<b>Subject:</b> <b>RATTLE NOISE FROM INSTRUMENT PANEL AND/OR CREAK NOISE FROM A-PILLAR OVER ROUGH / BUMPY ROADS</b>	<b>Bulletin No:</b> 09-002/14
	<b>Last Issued:</b> 10/03/2014

- This bulletin supersedes the previous bulletins 09-002/14 issued 01/08/14, 09-009/12 issued 03/09/12, 07/03/12 and 08/02/12. The APPLICABLE MODEL(S)/VINS and REPAIR PROCEDURE have been revised.
- Changes are noted below in Red beside the change bar.

### Rattle Noise From Instrument Panel:

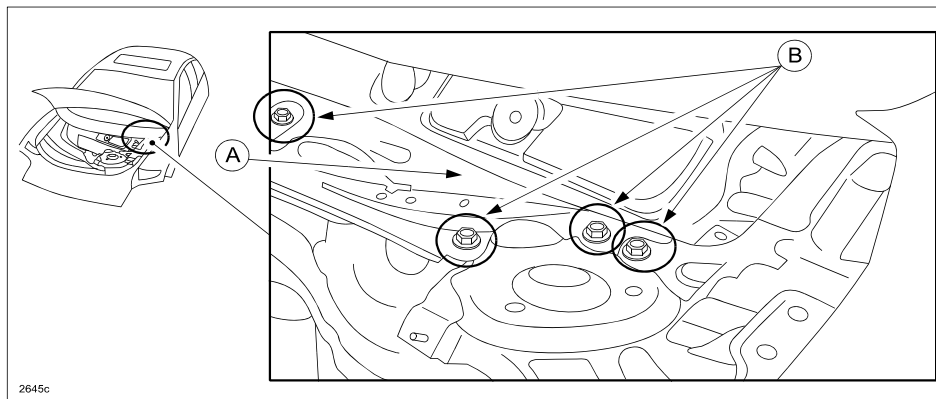
The rattle noise may be caused by low cowl panel (A) mounting bolt (B) torque.

2. Retighten all ten (10) cowl panel bolts (A) to:  
**Tightening Torque: 17-22 ft. lbs {22-30 Nm, 2.3-3.0 kgf-m}**
3. Reinstall the cowl grille according to the online MS3 instructions or the Workshop Manual (section 09-16 COWL GRILLE REMOVAL/INSTALLATION).

**Creak Noise From A-Pillar:**

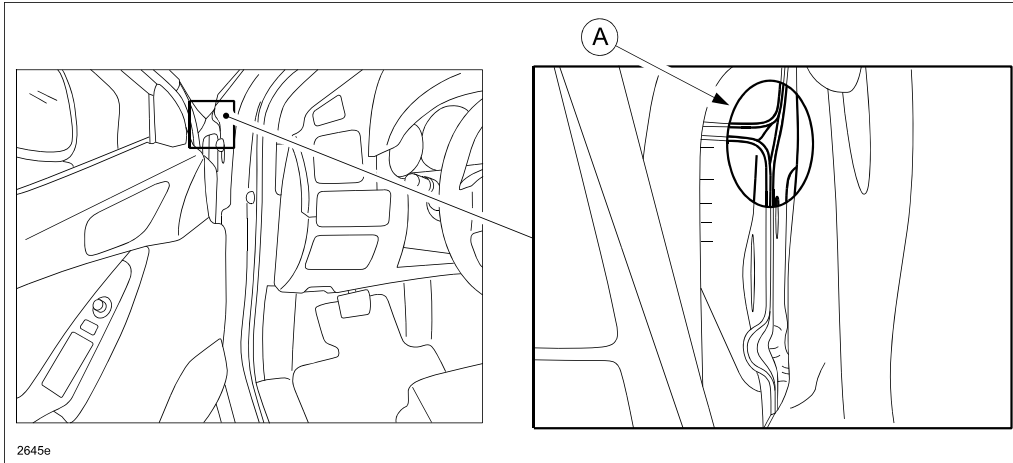
This noise may be caused by two joined panels (A) scraping together at the A-pillar. The panel weld areas have been improved during the mass-production of vehicles with VINs JM3KE\*\*\*\*\*128359 (produced June 1, 2012) or higher.

Enlarge the clearance between two (2) panels (A) using an appropriate tool (i.e. flat-blade screwdriver).

### Creak Noise From A-Pillar:

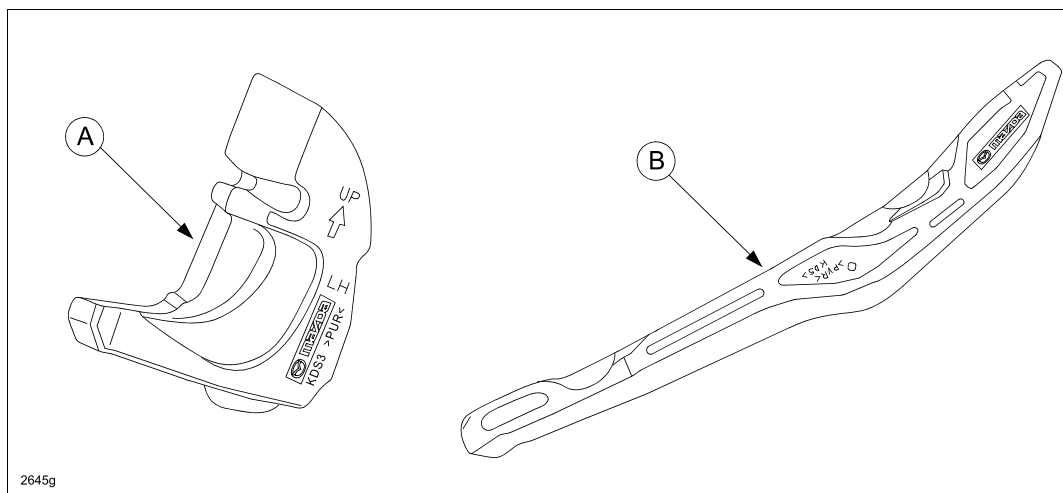
**NOTE:** In the illustration (below, right), the front fender is removed for viewing purpose only. It is not necessary to remove the front fender for this repair.

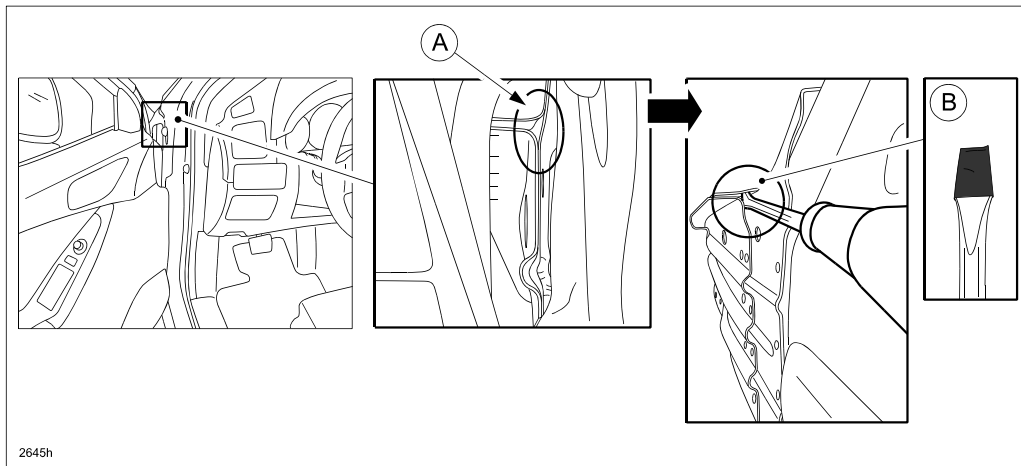
4. Open the front door and place a flat-blade screwdriver with protection tape on the tip (B) between the two panels at joint (A).

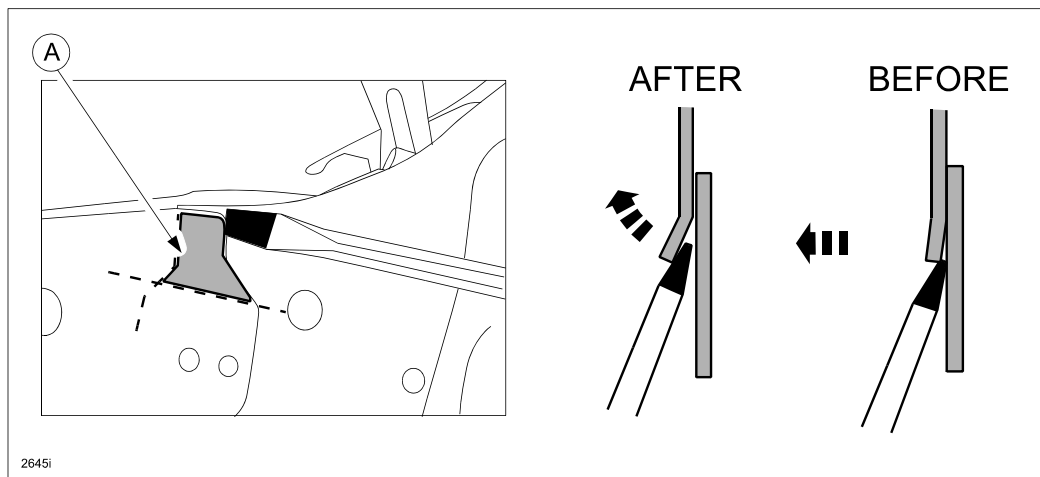
5. Bend the cowl side reinforcement panel (A) to create a clearance of more than 1 mm between the panels.

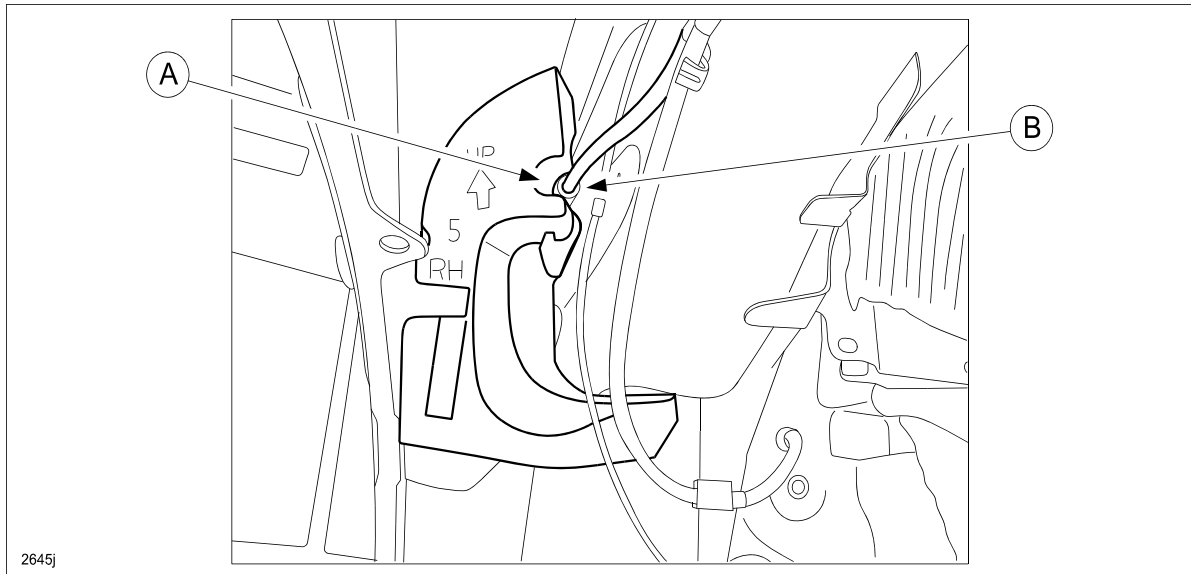
**NOTE:** Passenger Side Only: When reinstalling the cowl side seal plate, make sure to install the rear window washer hose (B) in the opening (A) to avoid hose damage.
